Addendum to the
Environmental Impact
Assessment Report

NISA
North Irish Sea Array

Marine Processes Review of Project Options

June 2026

Figure A4. Isochore contours to top of bedrock across the array area (Project Option 1) (replaces Figure 3 in Appendix 10.1 of the 2024 EIAR)

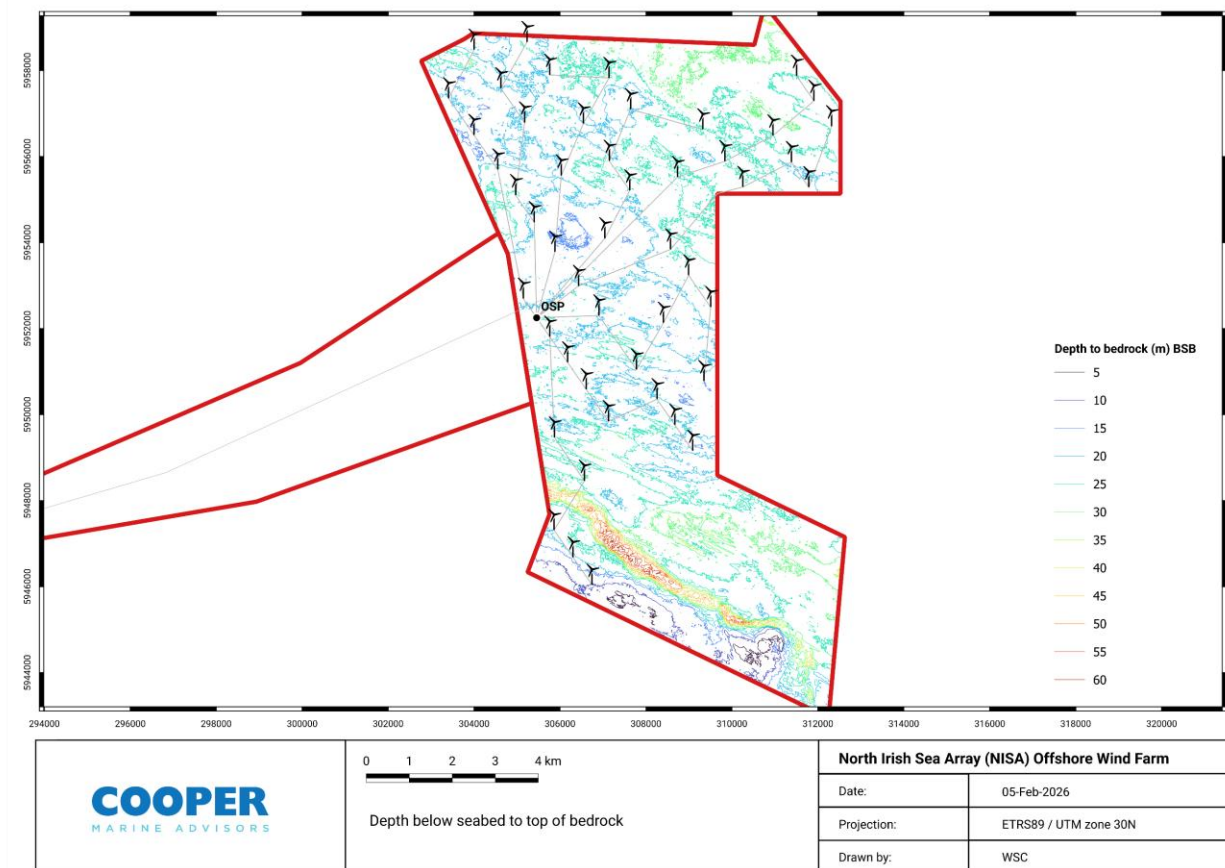
Changes are required to this section to reflect the revision of the foundation types for Project Option 1 and Project Option 2. Further information on the design refinements made in response to the RFI, third-party submissions and the continued public and stakeholder consultation is found within Appendix A5.1 Design Refinements. WTGs are now proposed with suction bucket foundations, and OSPs with jacket foundations installed with either pin piles or suction bucket foundations. Additional changes are due to the more recent site information gathered in response to (RFI 1(b)) where An Bord Pleanála requested the scientific information provided as part of the planning application documentation should be based on

up-to-date survey reports and data, which is identified in Section 1.2. Therefore, Section 4.2.5 of Appendix 10.1 of the 2024 EIAR shall be deleted and replaced with the following:

The ground model for the proposed development (GDG, 2024) interprets the available geophysical and geotechnical data with the depth to bedrock at the OSP locations at around 23 m below seabed (Figure A4). Above the bedrock are various layers of glacial till overlain by Holocene sediments which are predominantly formed of fine particles.

Drilling is planned to a depth of 60 m below seabed to secure the pin piles into the sub-surface layer of bedrock. Details of the underlying seismic stratigraphic (geological) units over this depth are taken from the proposed development’s Ground Model (GDG, 2024). Unit 1 to Unit 6 represent the upper soil layers to around 23 m below seabed and comprise of Holocene sediments over glacial till. Unit 7 is not present at the location of the OSP. From 23 to 60 m below seabed, Unit 8 represents a more resistant bedrock layer.

Figure A5. Surficial sediment types in northern part of array area

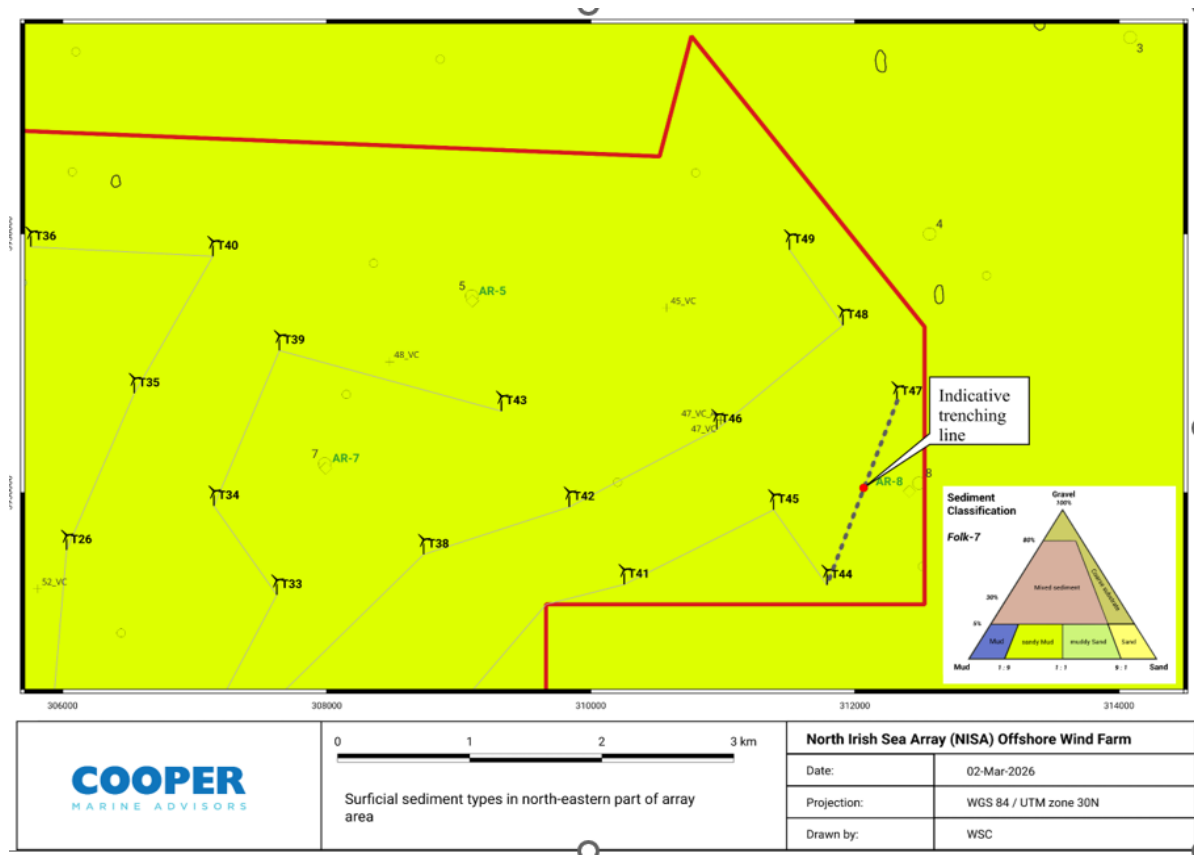
This section has been updated to incorporate the latest particle size analysis information from a benthic ecology survey undertaken in 2025 (Aquafact, 2025) as well as vibrocore data from a geotechnical survey in 2024 (N-Sea, 2024), in addition to a modified indicative array layout. Therefore, Section 4.2.3.e in Appendix 10.1 of the 2024 EIAR shall be deleted and replaced with the following:

Based on the indicative WTG layouts, and available sediment information from the geophysical and geotechnical surveys (Fugro, 2022 and N-Sea, 2024) and benthic surveys (Natural Power, 2022 and Aquafact, 2025), trenching in the north-eastern part of the array area is likely to encounter the highest proportion of fine sediments with the potential to form the largest sediment plume. This has been established based on the particle size analysis from grab samples #8 and #AR-8 (Natural Power, 2023 and Aquafact, 2025) and vibro-core sample 47_VC (N-Sea, 2024).

Accordingly, the array area cable trenching scenario applies a 1.5 km section of inter-array cables for this area, running between WTG-T47 to WTG-T-44, Project Option 1 (Figure A5).

Figure A6. Surficial sediment types along the ECC (replaces Figure 4 in Appendix 10.1 of the 2024 EIAR)

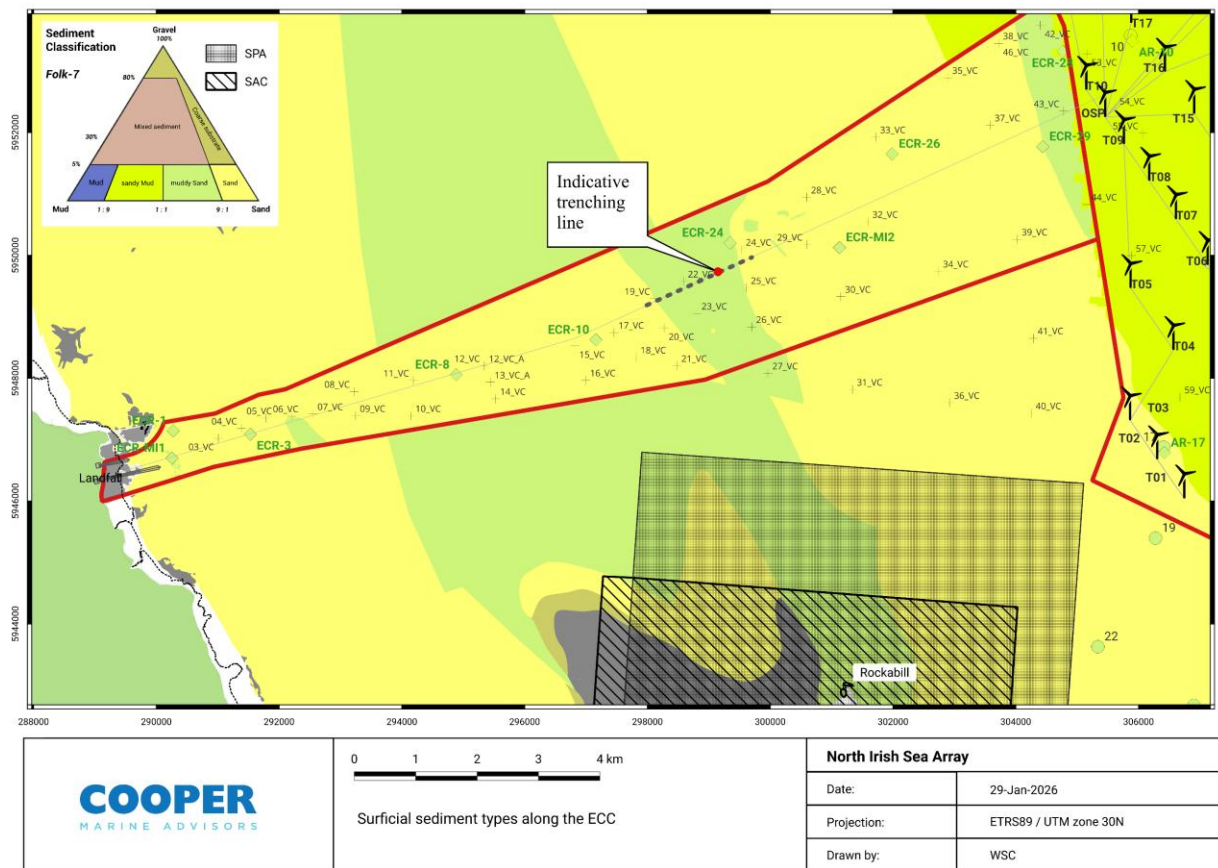
This section has been updated to incorporate the latest particle size analysis information from a benthic ecology survey undertaken in 2025 (Aquafact, 2025) as well as vibrocore data from a geotechnical survey in 2024 (N-Sea, 2024). The indicative ECC cable route remains unchanged. Therefore, Section 4.2.3.f in Appendix 10.1 of the 2024 EIAR shall be deleted and replaced with the following:

The area considered to have the highest content of fine sediments along the ECC is where the geophysical survey (N-Sea, 2023) interprets a region of muddy Sand (clayey Sand) immediately seaward of the shallow sand ridge emanating to the north-west of Rockabill (Figure A6). This location is also to the north of the Rockabill Special Protection Area (SPA) and Rockabill to Dalkey Island Special Area of Conservation (SAC). Therefore, sediment plumes dispersing from trenching in this area would present the worst-case to these designated areas.

The distance for the indicative export cable alignment to cross the area of ‘muddy Sand’ is estimated to be at least 1.47 km. To note, the broader-scale interpretation of seabed sediments provided by INFOMAR suggests the area of muddy Sand could be much wider and also extend further to the west.

Figure A7. Surficial sediment types towards the landfall area (replaces Figure 5 in Appendix 10.1 of the 2024 EIAR)

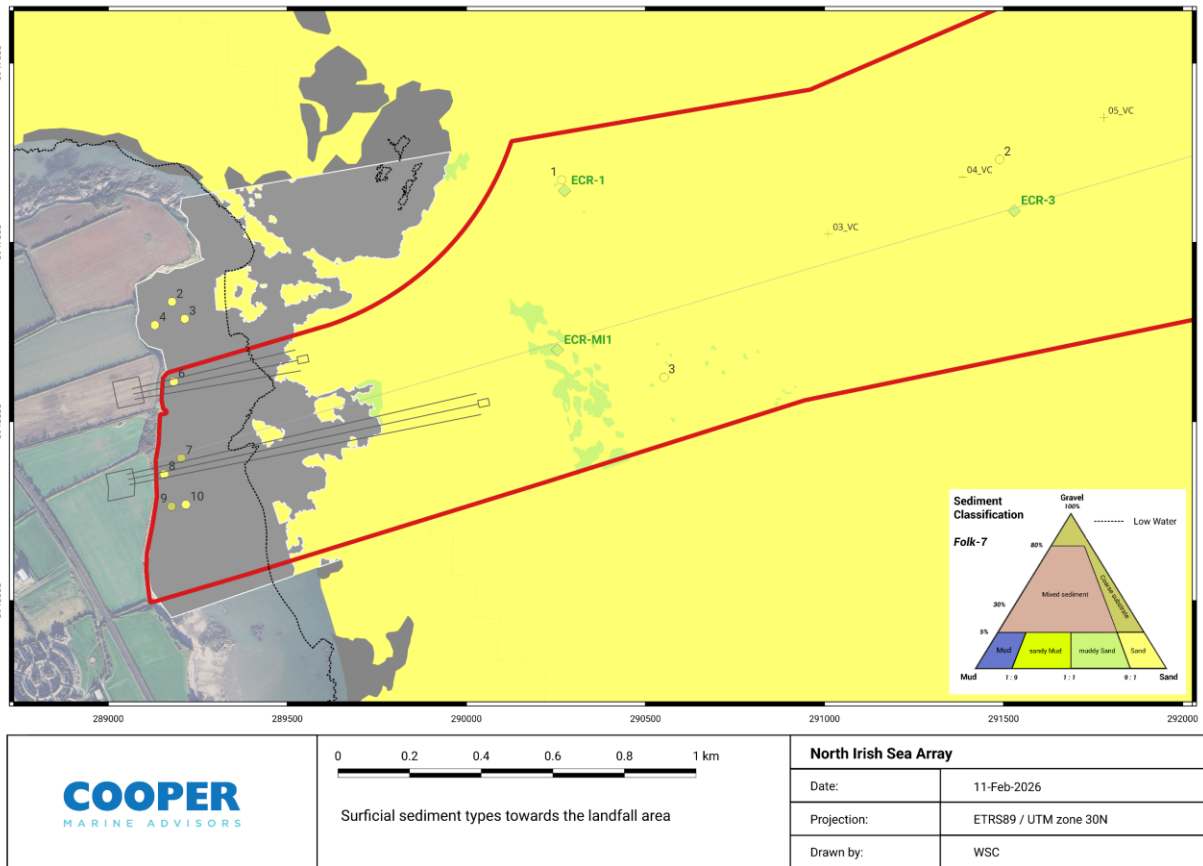
Changes to this section are a result of further nearshore geophysical surveys of the ECC undertaken by SEP Hydrographic in 2024 and the latest particle size analysis information from a benthic ecology survey undertaken in 2025 (Aquafact, 2025). This includes Figure 5 in Appendix 10.1 of the 2024 EIAR which shall be deleted and replaced with Figure A7, mapping the surficial sediment types toward the landfall area and Table 9 in Appendix 10.1 of the 2024 EIAR which shall be deleted and replaced with Table A5 presenting a breakdown of fine sediments from the excavation of exit pits by MFE. Therefore, Section 4.2.4 a. in Appendix 10.1 of the 2024 EIAR shall be deleted and replaced with the following:

Geophysical surveys of the nearshore area of the ECC (N-Sea, 2023 and SEP Hydrographic, 2024) interpret surficial sediments in this area as mainly ‘Sand’, along with patches of ‘muddy Sand’ (Figure A7).

The content of fine sediments is assessed with reference to surficial sediments from grab sample ECR-MI1 (Aquafact, 2025)) and near-surface sediments and sediment density from vibrocore 03_VC (N-Sea, 2024), in particular. These sites are considered to remain within the same geological unit, interpreted as GU1 (GDG, 2024).

Figure A10. Annual wave rose within array area (MetOceanWorks, 2020) (replaces Figure 6 in Appendix 10.1 of the 2024 EIAR)

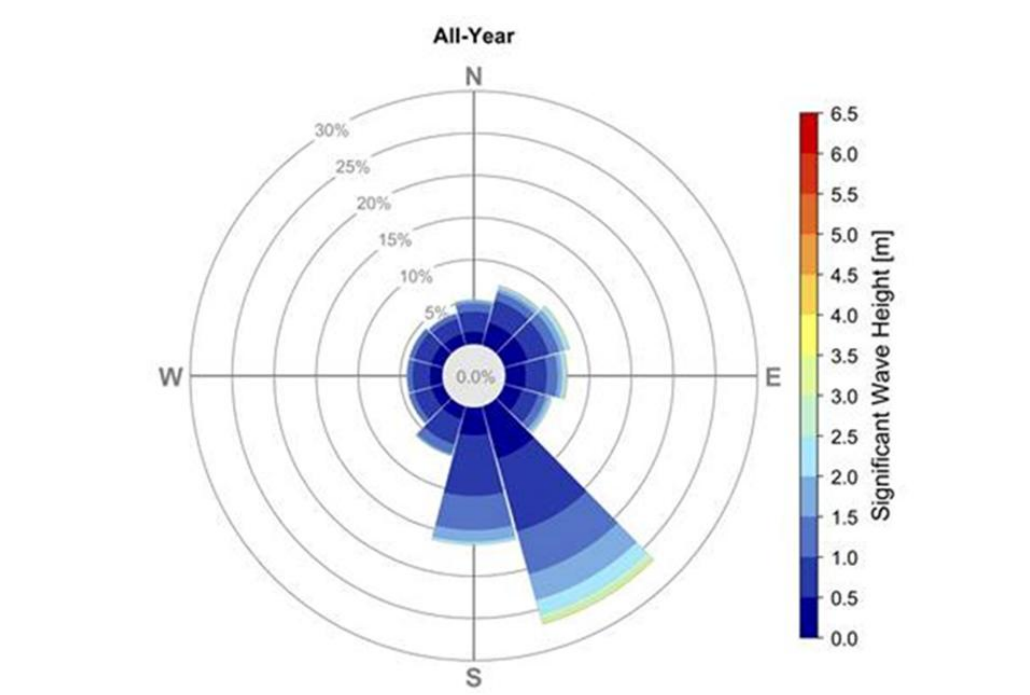
The change required in this section is due to the refinement of the installation method of the foundations for Project Option 1 and Project Option 2. Further information on the design refinements made in response to the RFI, third-party submissions and the continued public and stakeholder consultation is found within Appendix A5.1 Design Refinements. In the 2024 EIAR, array-scale issues were determined based on WTG monopile foundations and OSP monopile and jacket foundations with pin piles. WTGs are now proposed with suction bucket foundations, and OSPs with jacket foundations installed with either pin piles or suction bucket foundations. Array-scale changes are therefore based on these latest refinements. Therefore, Section 4.3.4 b. in Appendix 10.1 of the 2024 EIAR shall be deleted and replaced with the following:

An additional consideration for array-scale blockage effects is the direction of approaching waves relative to the alignment of WTG across the array. The annual wave rose within the array area provides a basis for considering relevant wave directions (Figure A10).

The prevailing wave direction of 150° N ($\pm 15^\circ$) appears to be aligned with the long axis of WTG across the array area. Notably, the prevailing wave direction is also associated with the direction of largest waves (i.e., storm conditions). Waves from this direction are also responsible for developing the adjacent drift-aligned coastline.
